WEST MAIN STREET STREETSCAPE IMPROVEMENTS PHASE 3, WILLOW STREET CORRIDOR

RFP #2223-29

ADDENDUM NO. 1

June 16, 2023

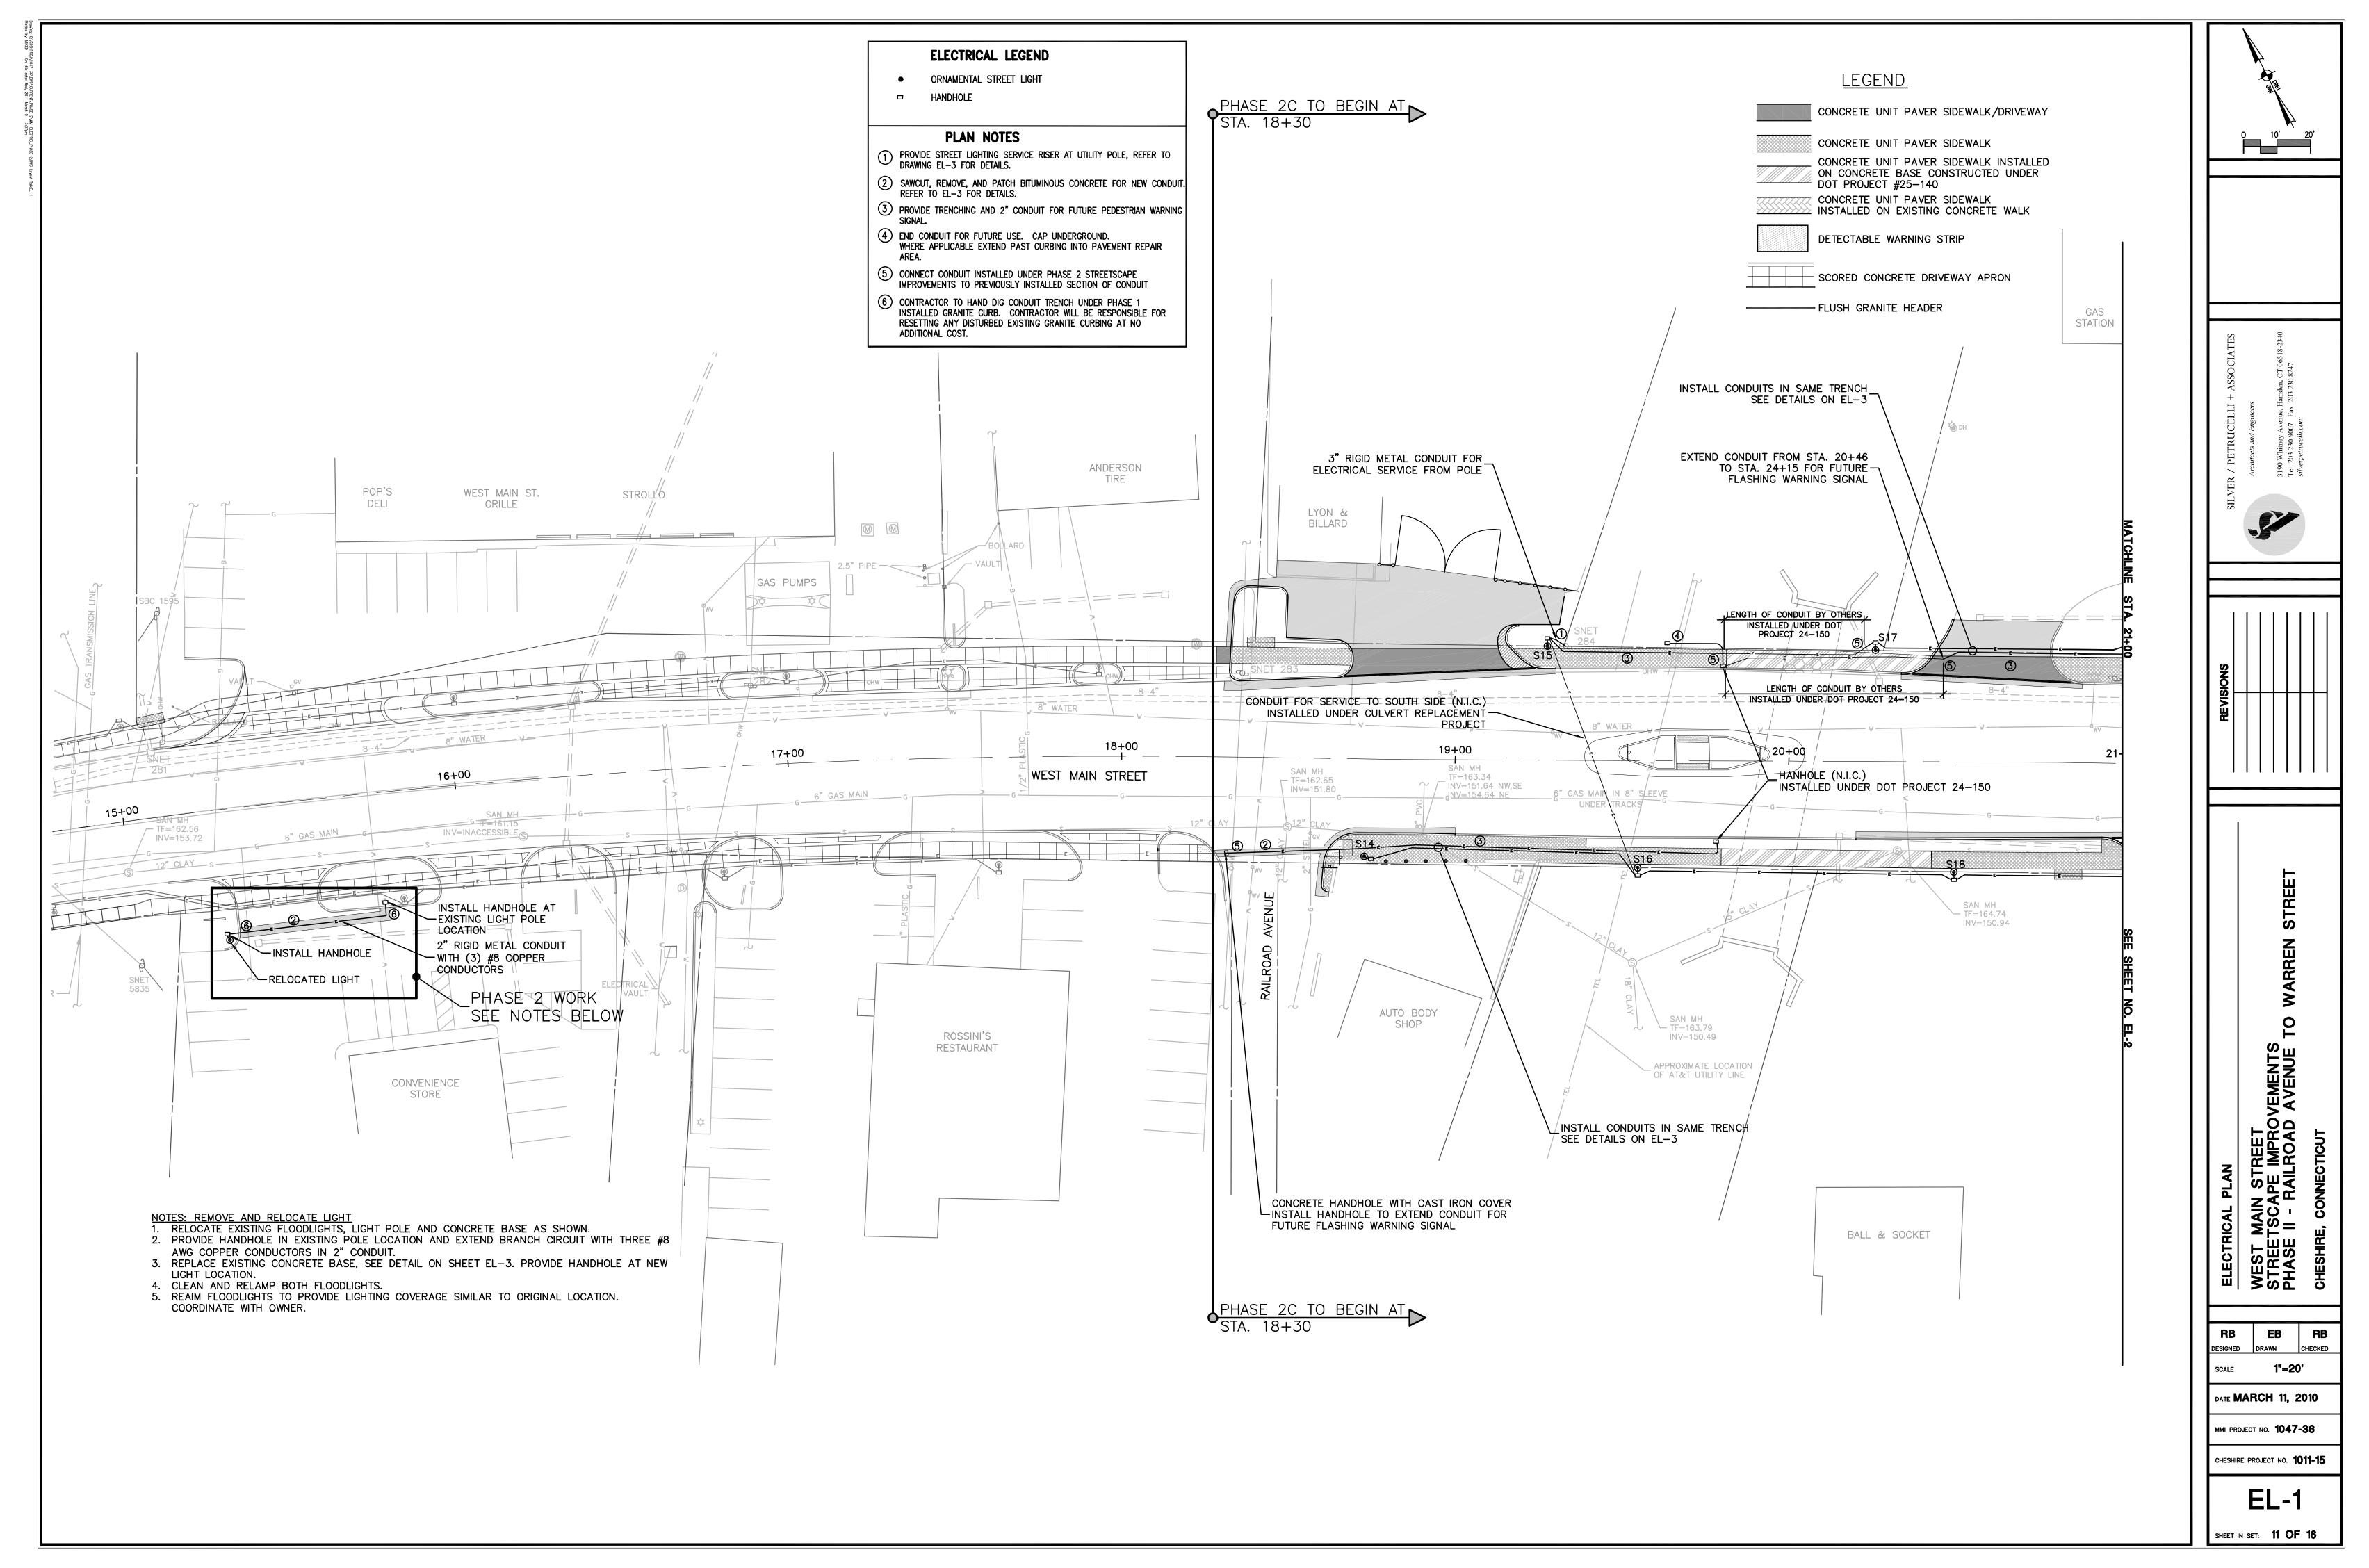
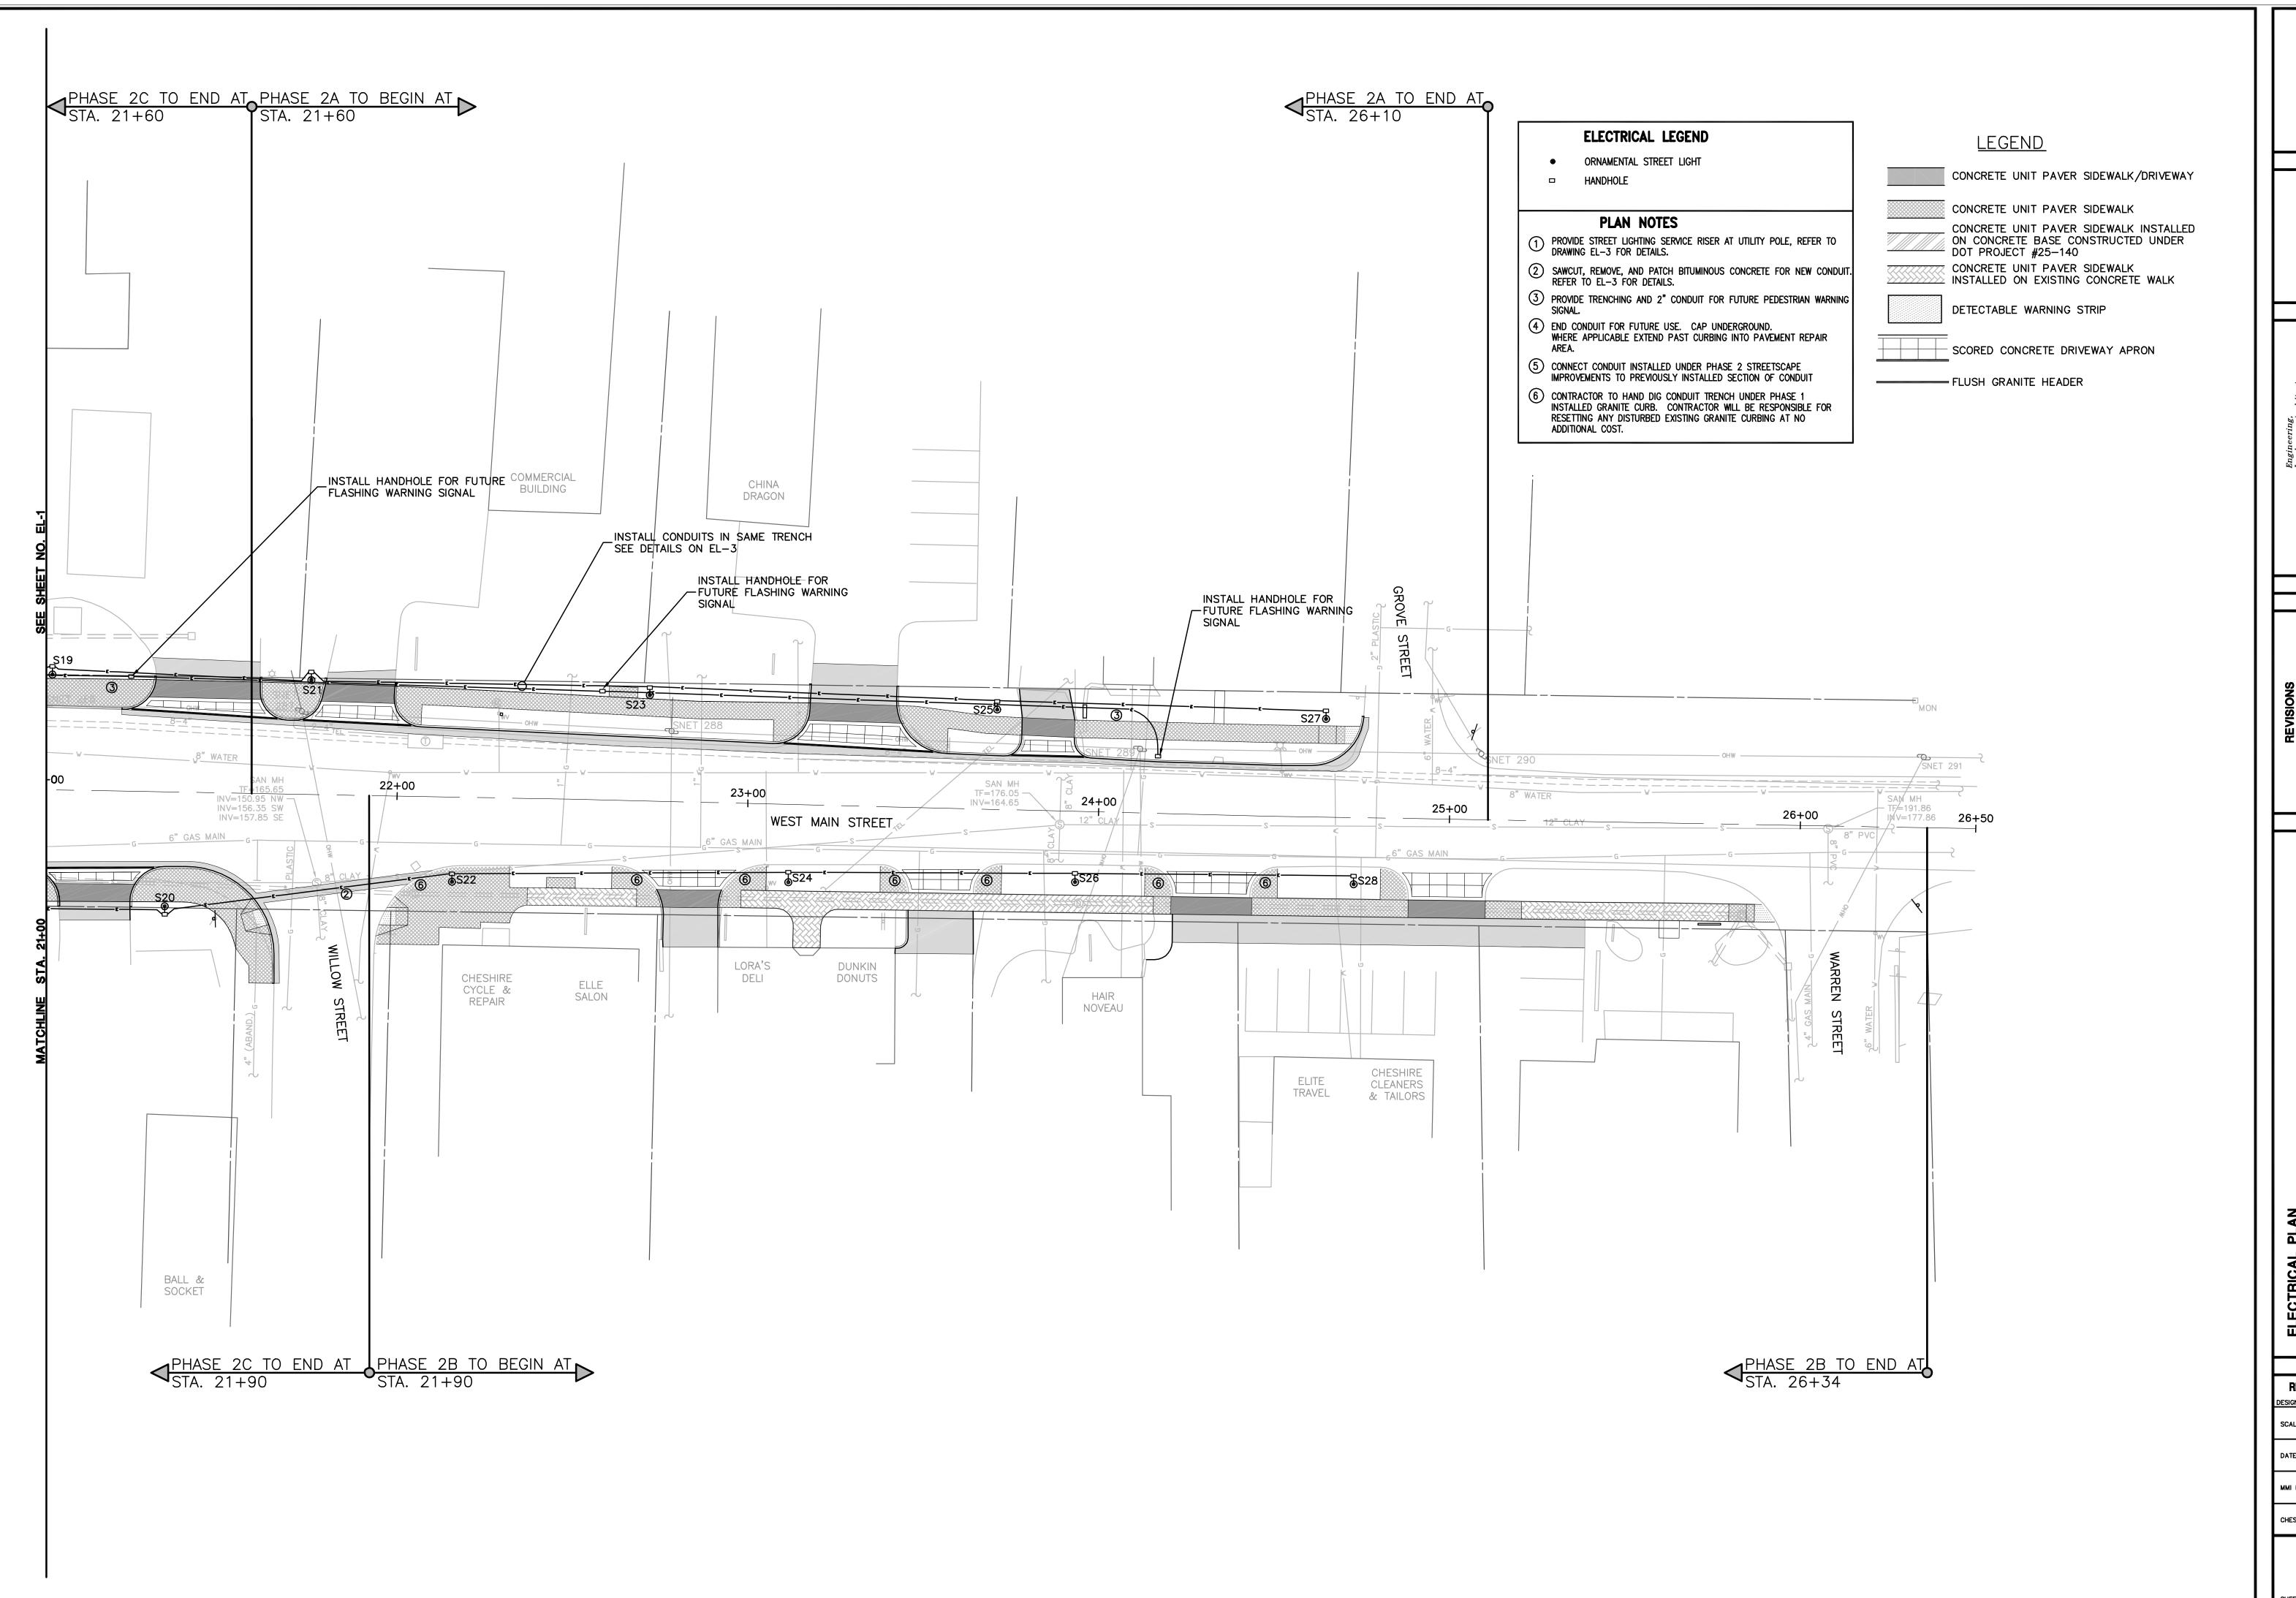
- **Question 2:** For the Site lighting is the site contractor responsible for conduit and wire? There is no detail showing where the electrical is coming from.

- Response 2: See attached Sk-C1 and drawings EL-1 thru EL-3 from the West Main Street Streetscape Project c. 2010. Power shall be obtained from the existing splice box at West Main Street and Willow Street. Contractor shall confirm sufficient power is available from this location and shall provide an Electrical Plan for the new lights along Willow Street as outlined in Specification Section 26-00-00. The Electrical Plan shall be signed by a Professional Engineer licensed in the State of Connecticut and shall be reviewed and approved by Town of Cheshire Building Department prior to installation.
